Matthew Rosel - Submission Details for Mitza Grocott (object)

Submission for Job: #5878 SSD 5878-2013 Sydney International Convention, Exhibition and Entertainment Centre Precinct - Mixed use Development in the Southern Haymarket Precinct (Concept Proposal)
https://majorprojects.affinitylive.com?action=view_job&id=5878

ERRORS OF COMMISSION AND OMISSION IN PUBLIC DOCUMENTS

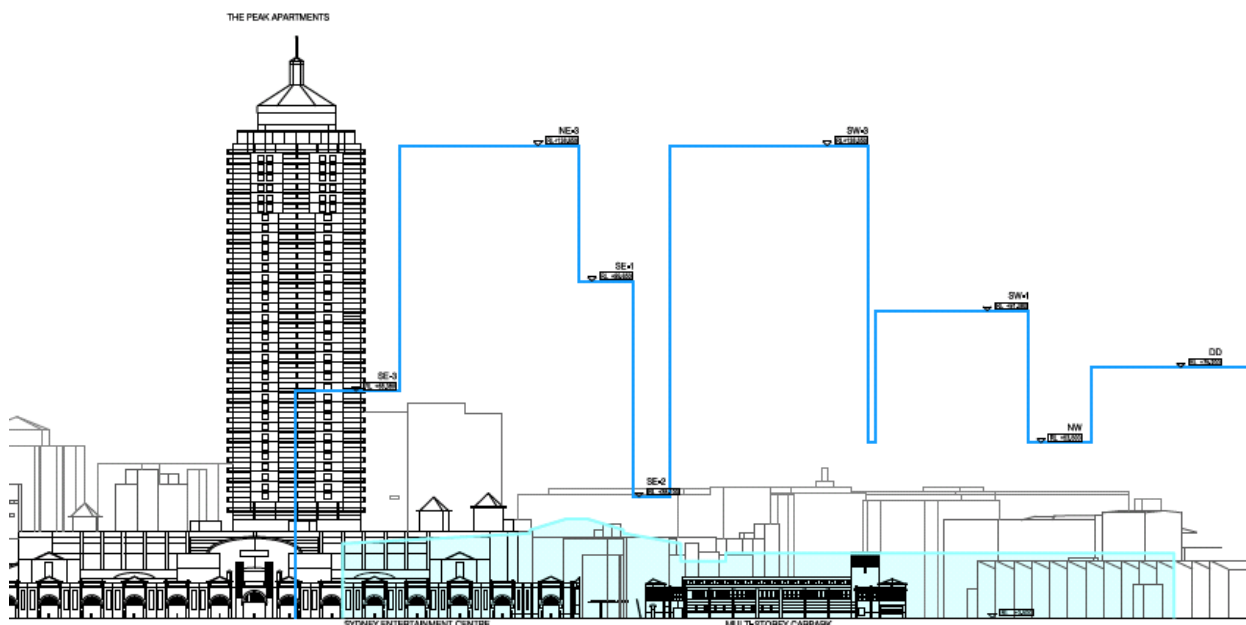
Is the site area **43,880m²** or **47,530m²** ? Whichever figure is used, neither equates to an FSR of 4.3:1

The real area between Hay Street, Pier Street, Harbour Street and Darling Drive is in fact nearer to **30,000m²**.

The following photos illustrate the situation today....

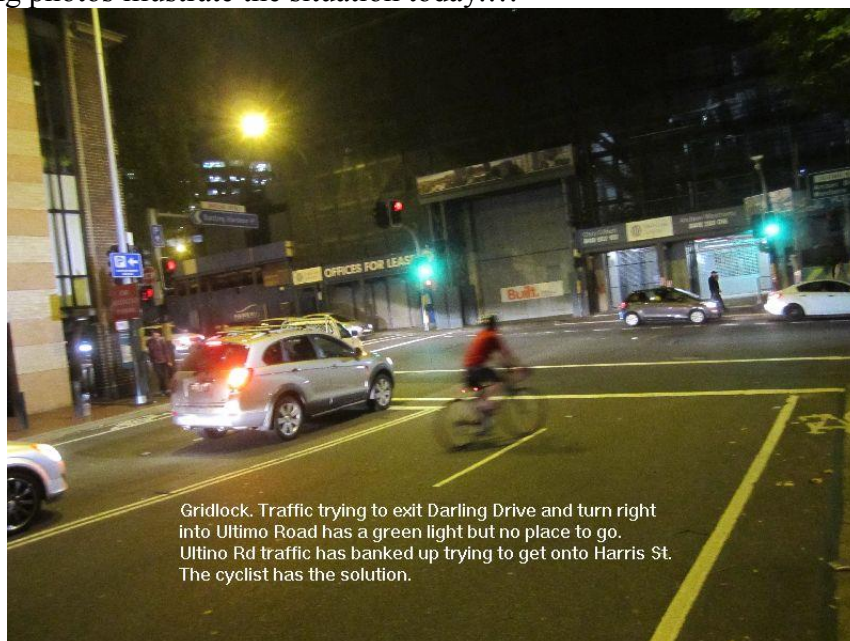
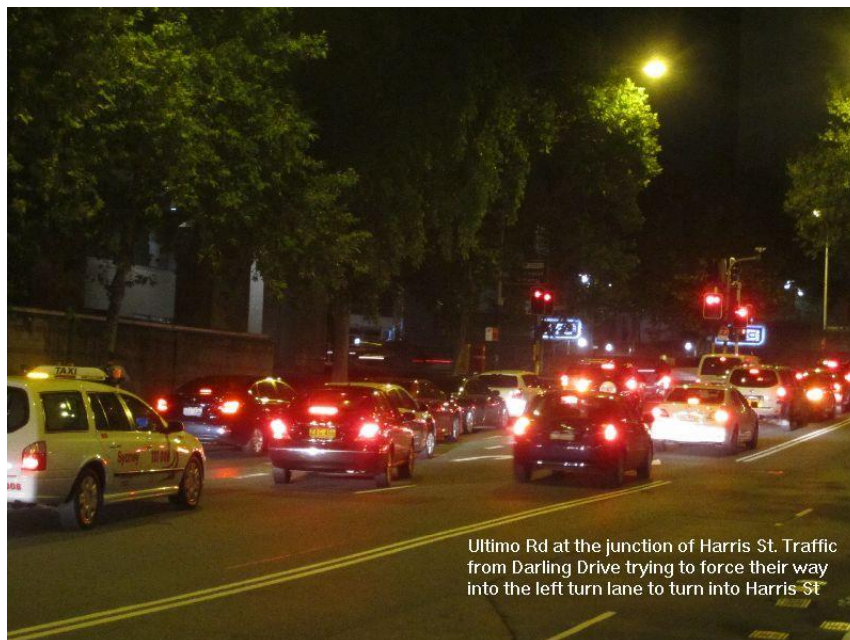
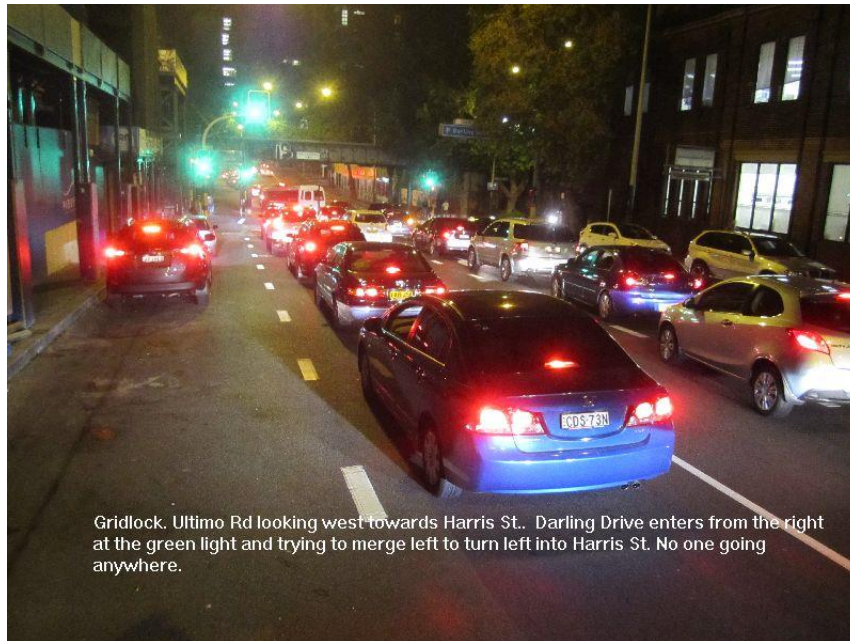
This illustrates how Ultimo Road is key. Westbound it is already very congested at its junction with Harris Street, where most vehicles wish to turn left onto Harris Street.

Vehicles turning right from Darling Drive into Ultimo Road, with the intention of turning left onto Harris Street have no option but to turn into the RH lane (as if to turn right onto Harris Street) and then push into the left hand lane across the cycle path. This is the only way to get 4-6 cars, per traffic light cycle, from Darling Drive onto Ultimo Road. When Darling Drive is fully utilised under the new development, there will be LoS E (unacceptable) condition at the junction with Ultimo Road.

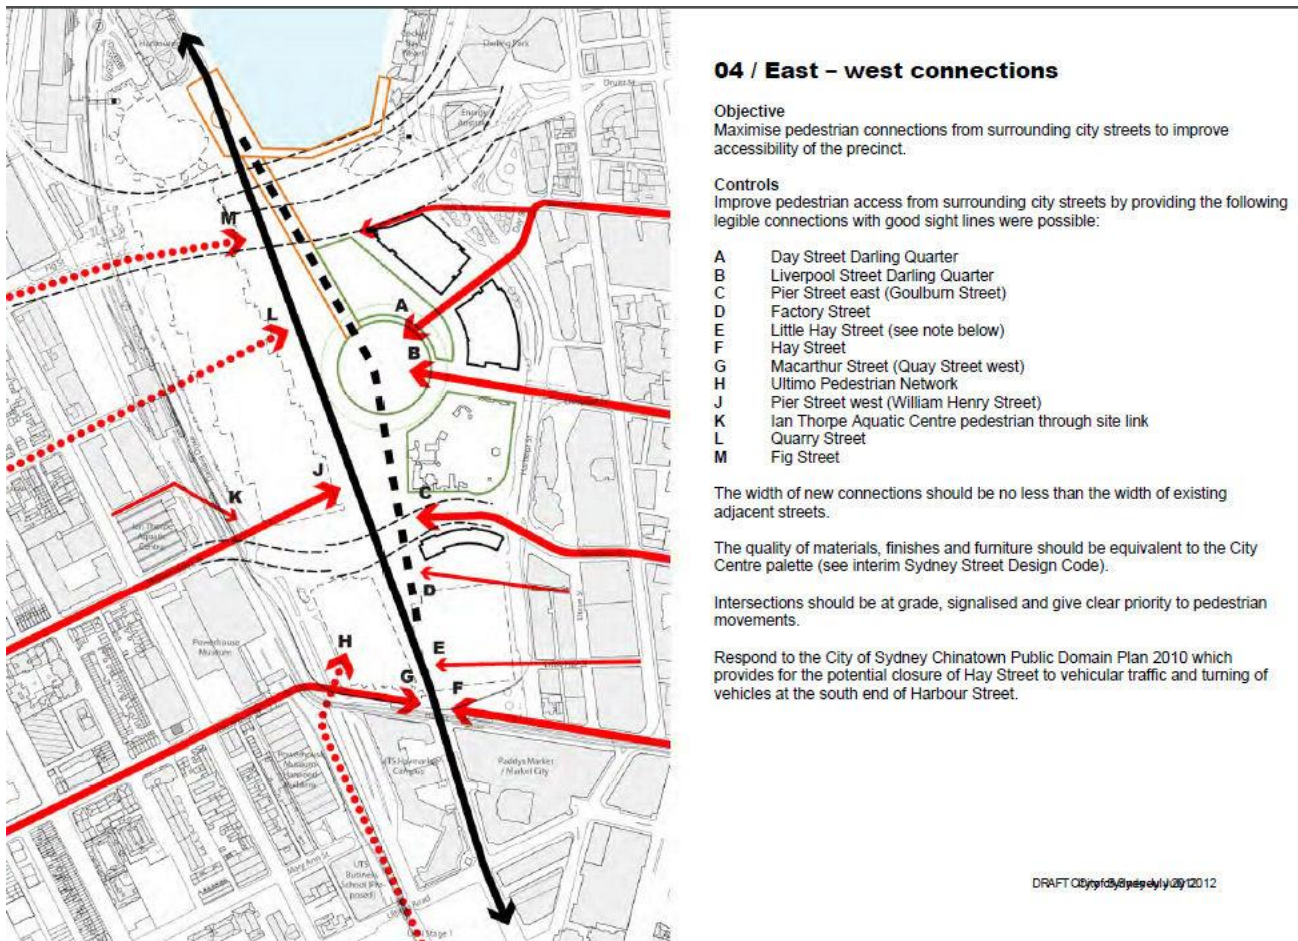
At the Western end, in busy periods, cars normally have to wait about 8 sets of lights to turn right (west) at the fishmarkets. The study notes this is a Los E (unacceptable) condition.

So it is not unrealistic to assume that while Darling Drive can just about handle the traffic density at the moment, any increase will very quickly result in bottlenecks caused by the extra traffic at the exits from Darling Drive.

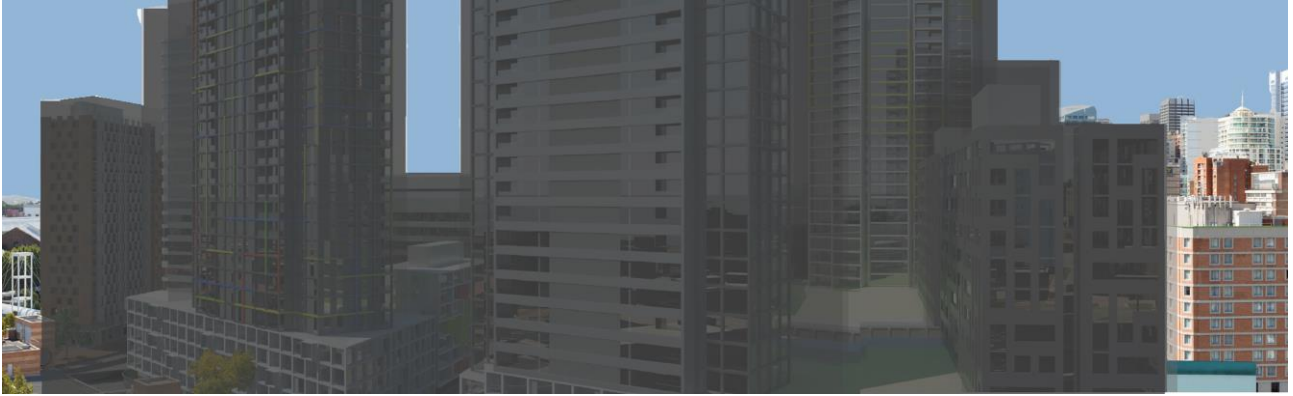
It is common practice to share views between existing and new private buildings when planning new developments. Where public views are involved they normally take some degree of precedence over existing private views – the greater good etc.

This proposal flouts this practise with no apology and will deprive many people of sunlight as well as their existing pleasant outlook. These photographs illustrate what will happen to the northward views of apartments in The Peak at lower, mid and higher levels.

Which will become ...

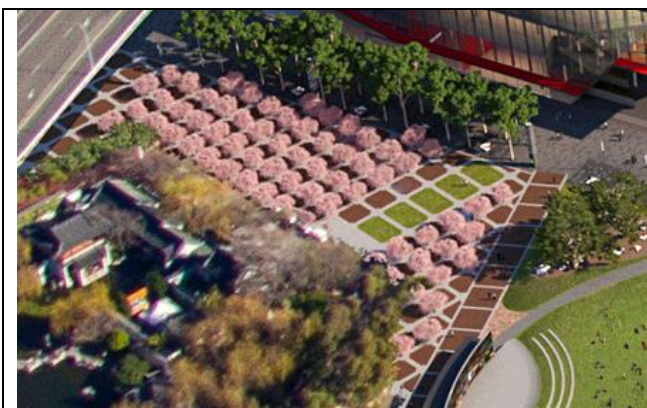
Only those on the top few floors of The Peak will retain more than 20% of their northward views. View sharing just is not on the Lend Lease agenda. Normally public views take precedence over private views. In this case new private views will take precedence over existing private views.
